GRID CONNECTIVITY TO TFL TO SUPPLY 90 MW POWER AND
CONSTRUCTION OF 220 KV LILO GIS

AMENDMENT – IV

NIT, No. PNMM/PC-183/E-4017/NCB Dated 20.06.2022

Sub.: GRID CONNECTIVITY TO TFL TO SUPPLY 90 MW POWER AND CONSTRUCTION OF
220 KV LILO GIS AT TALCHER FERTILIZERS LIMITED, TALCHER, ODISHA

CLIENT	TALCHER FERTILIZERS LIMITED
PROJECT	PTC INDIA LIMITED
DESIGN	220KV GIS SWITCHING SUBSTATION
APPROVED	14 MTR H POLE STRUCTURE
DATE	13/07/2022
SCALE	1:1
DRAWN	PTC/PTL/PTC/H POLE-08
CHECKED	
DATE

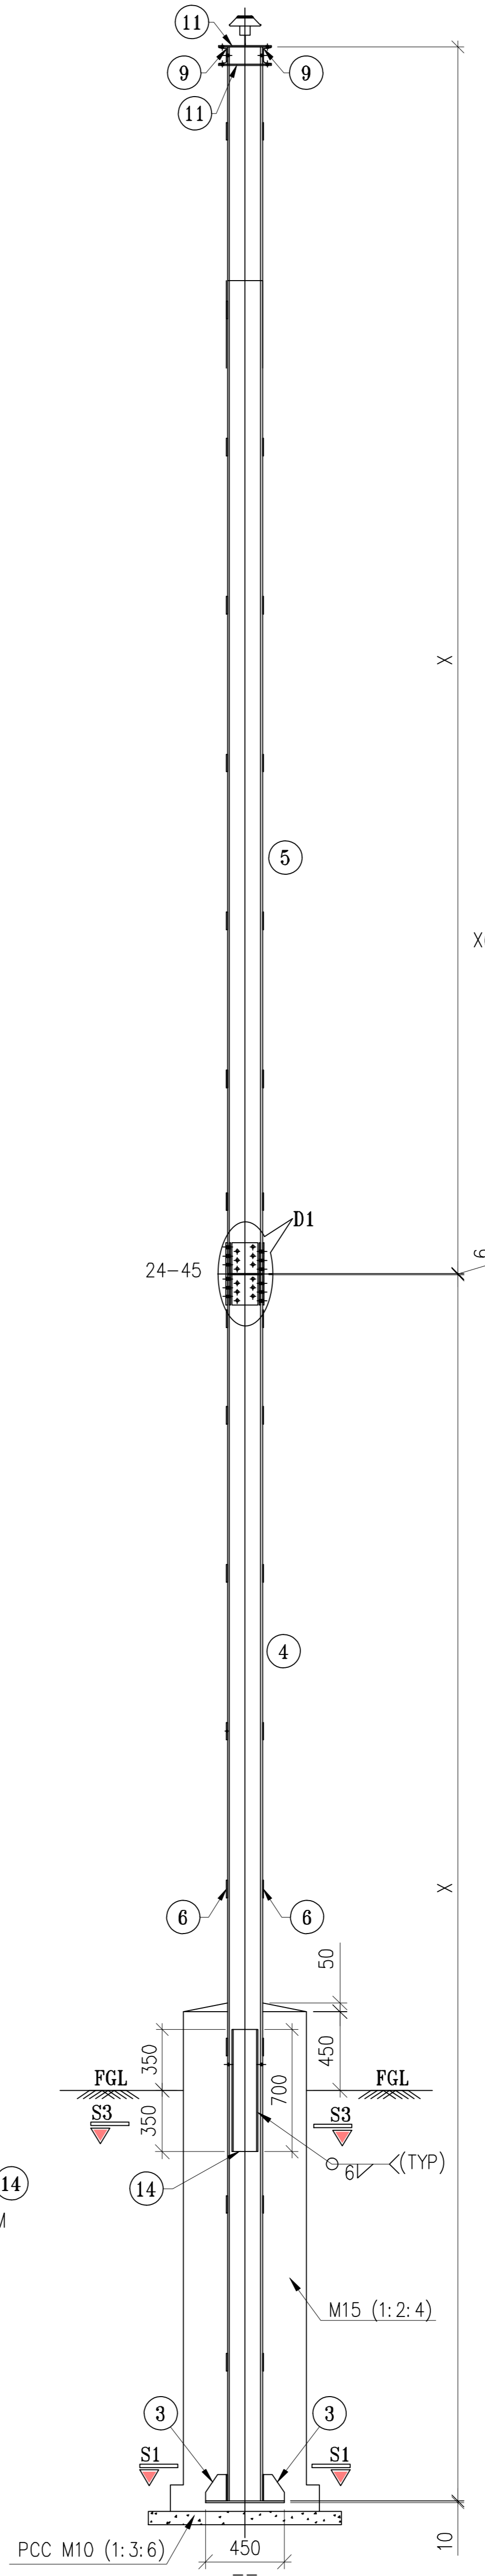
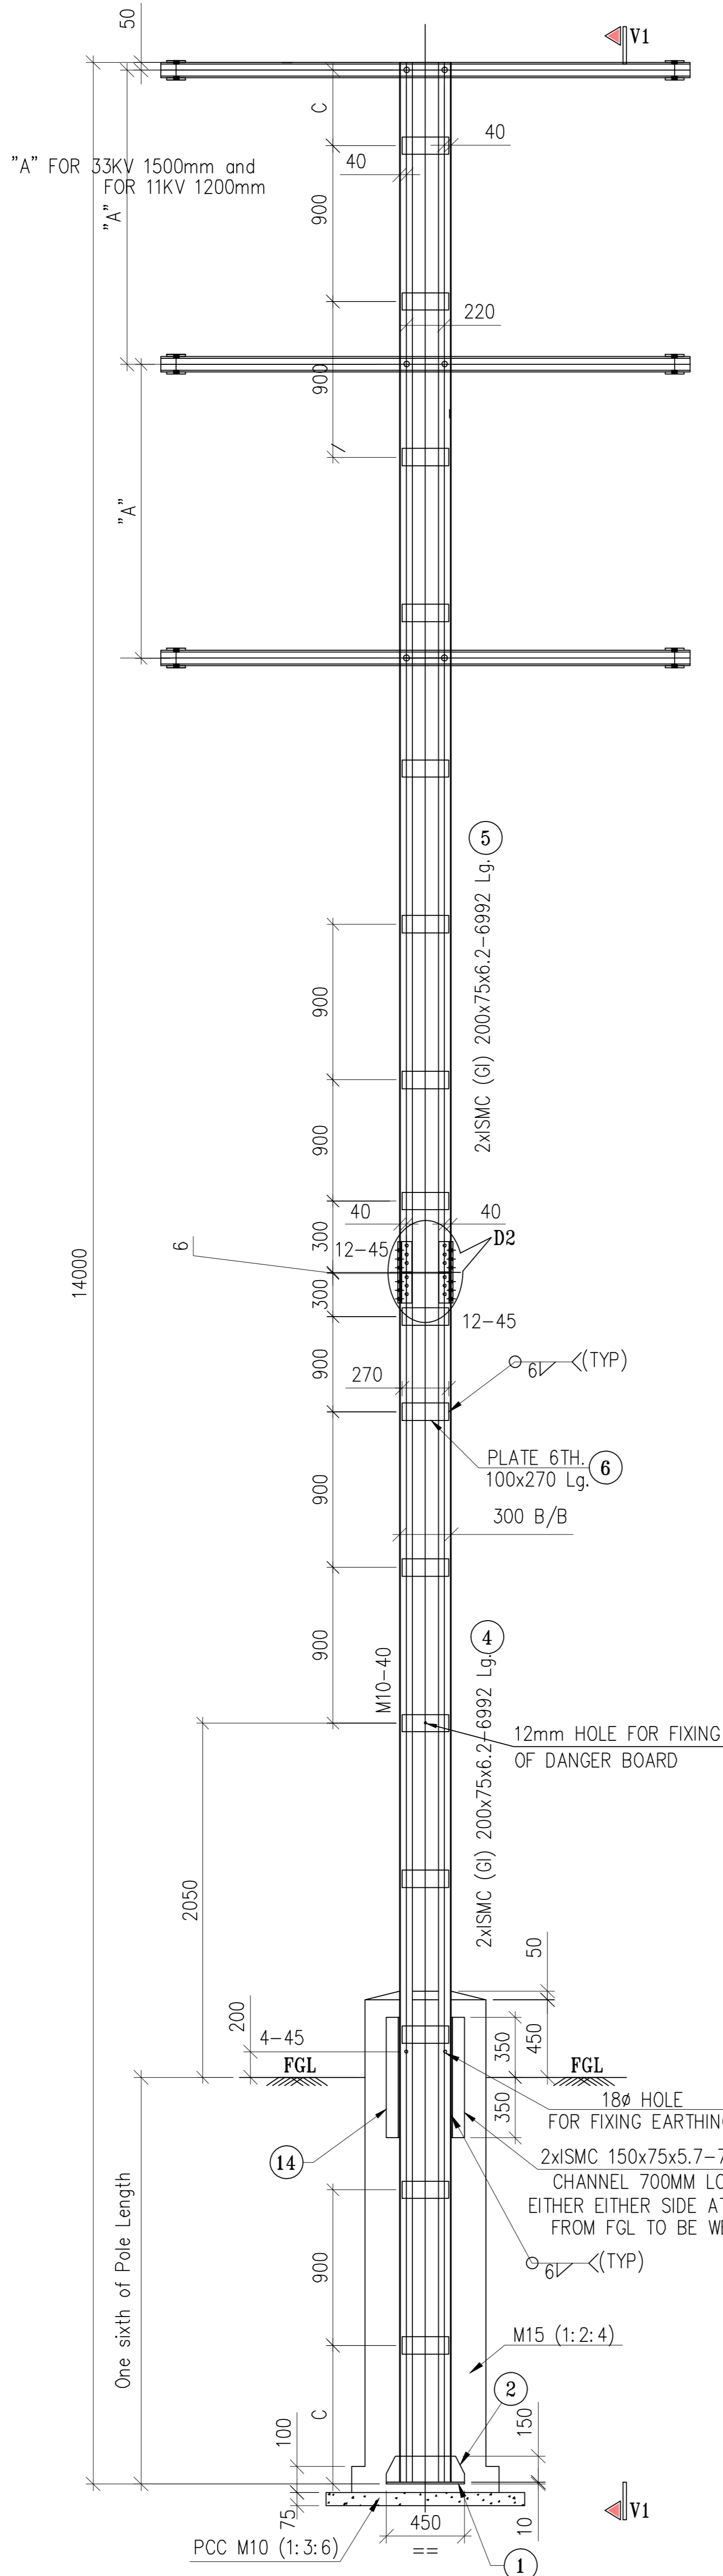
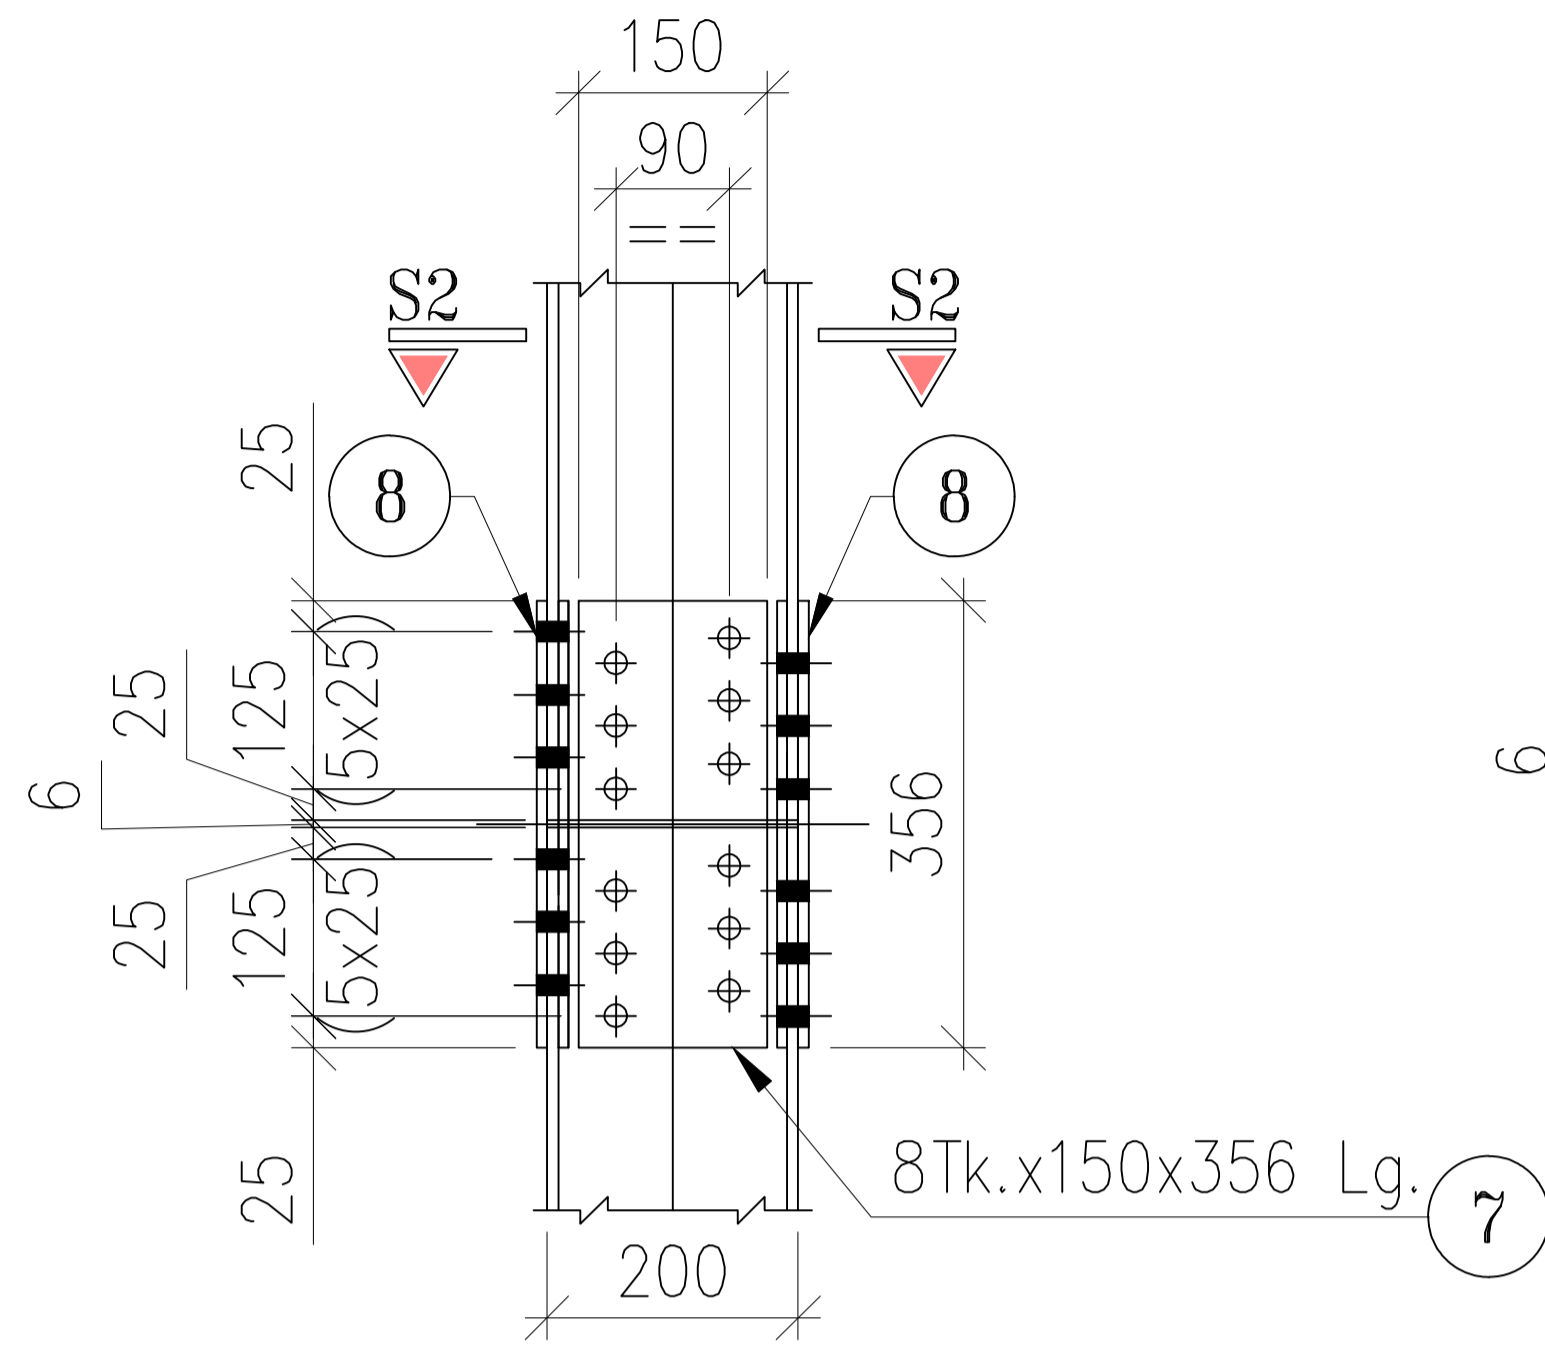
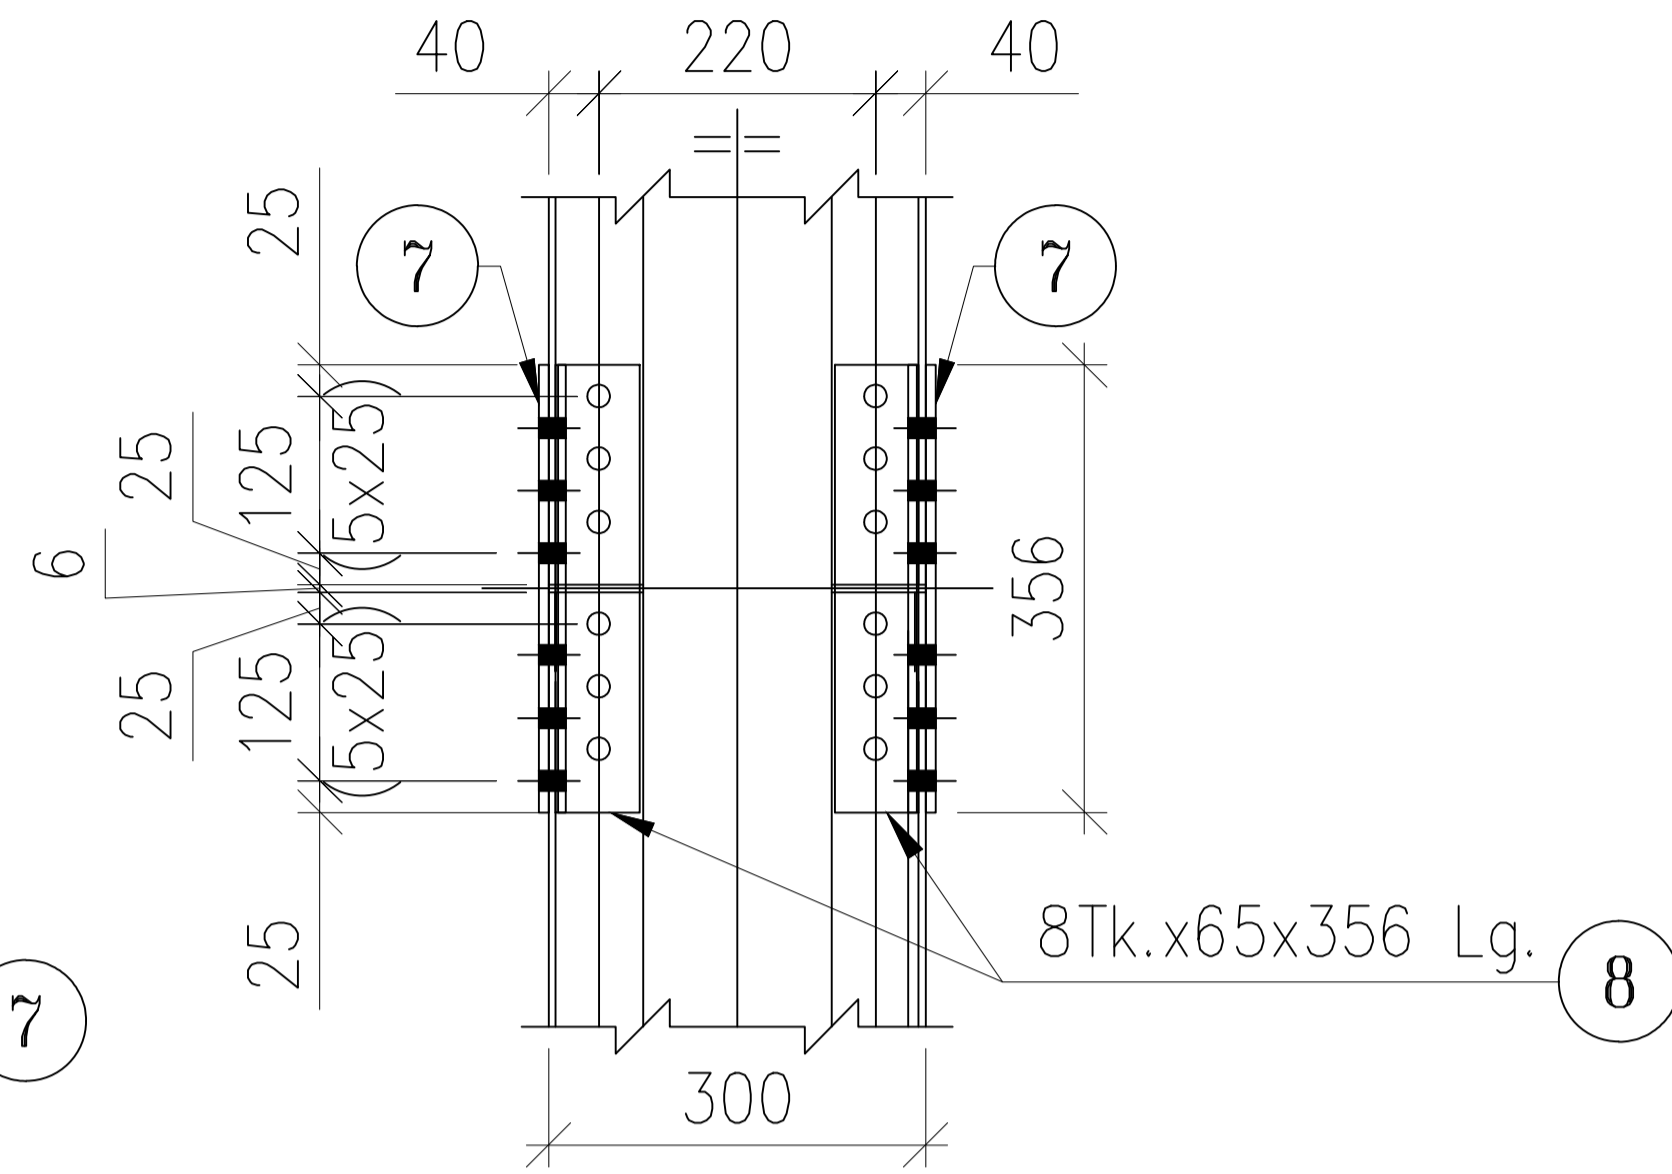
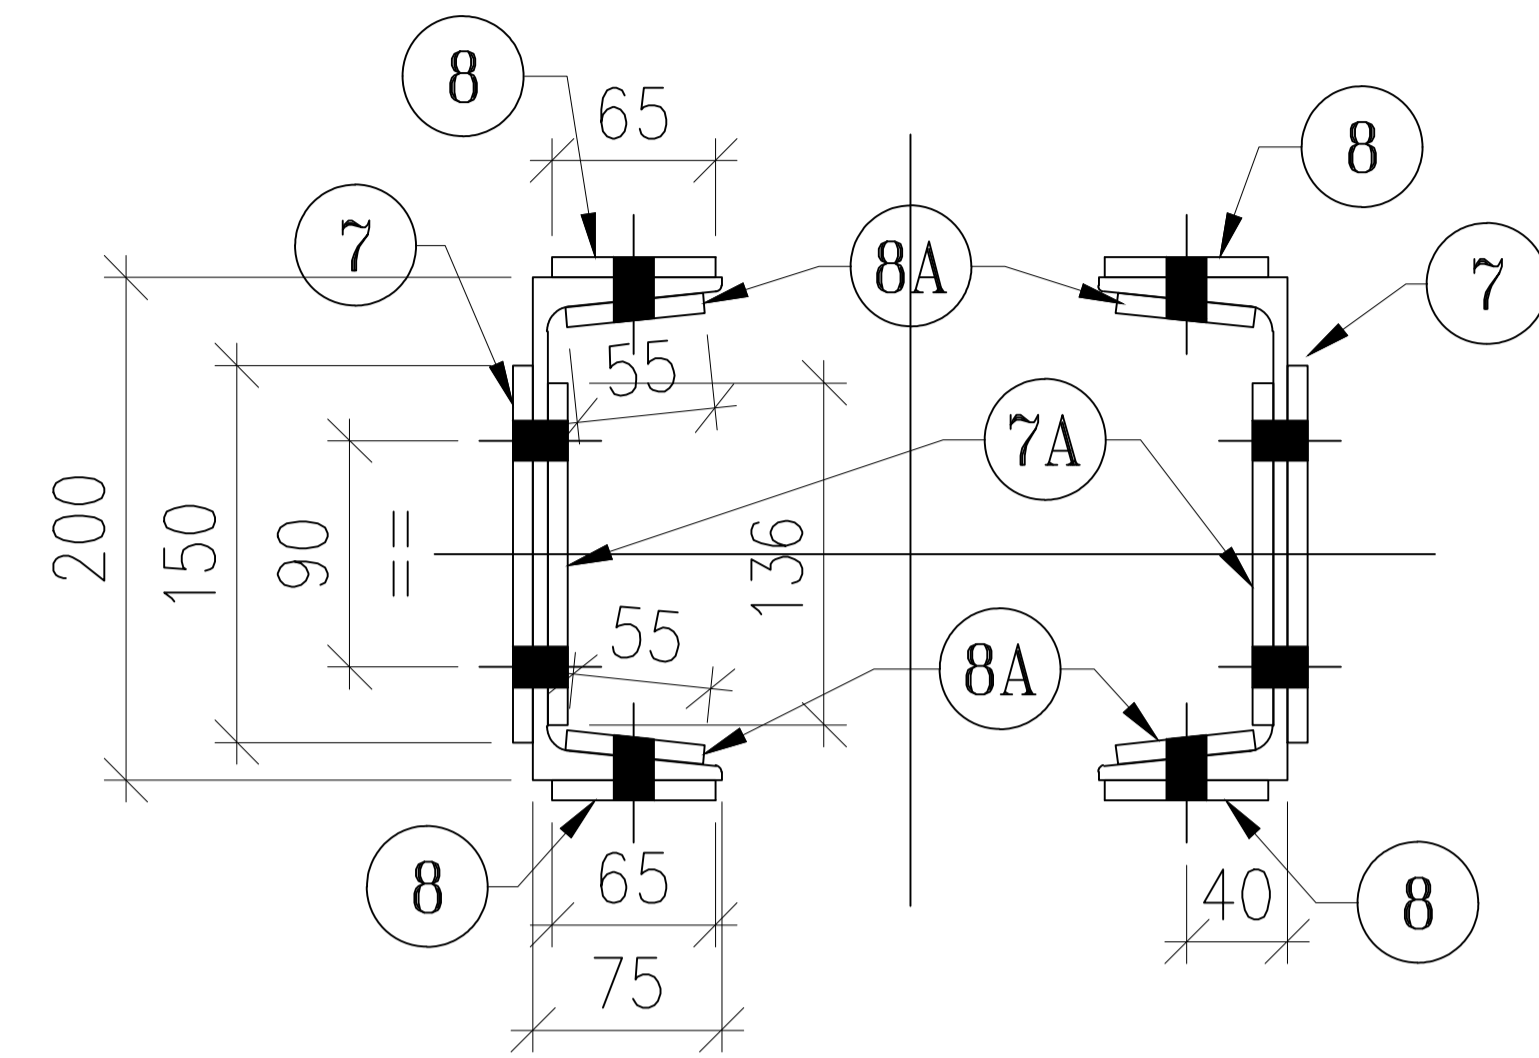
8)	TS	1615 of 1622	Annexure X – IV	Tender Drawings	Tender Reference Drawing of Triple Pole Structure	A	Refer Annexure G – “Tender Reference Drawing of Triple Pole Structure”
